Docket Item #7
BAR CASE #2004-0078

BAR Meeting
May 19, 2004

ISSUE: Third story addition
APPLICANT: Mr. and Mrs. Alan Frey
LOCATION: 411 South Fairfax Street
ZONE: RM/Residential

Figure 1 - Proposed Front (east) Elevation

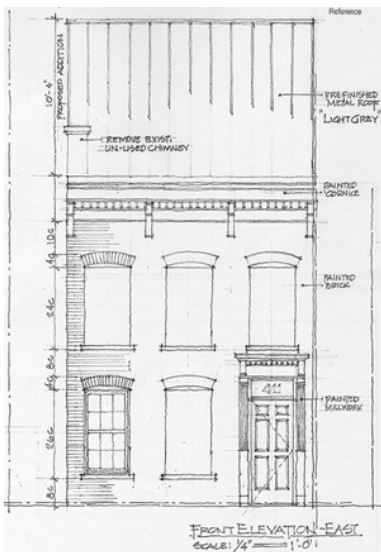
Even if Staff was to accept as desirable the addition of a gable-roofed third story to the front of an historic flat roofed building, Staff believes the design of the proposed addition is problematic. The height of the gable over the main block appears disproportionately tall for the existing two story house.

The unequal gable proposed for the main block, while not totally unprecedented in Alexandria, is odd in appearance. Preservation philosophy recommends that new construction be distinguished from the historic building. The north and south walls of the addition over the main block are to be clad in brick and the roof in standing seam metal. Consequently, Staff is concerned that the casual observer will be unable to discern that the third story is a modern addition. The three story ell is also an unusual form for Alexandria. Typically ells are no higher than two stories, even when the main block of the house is three stories. In this case, with a relatively small main block, the three story ell seems particularly inappropriate.
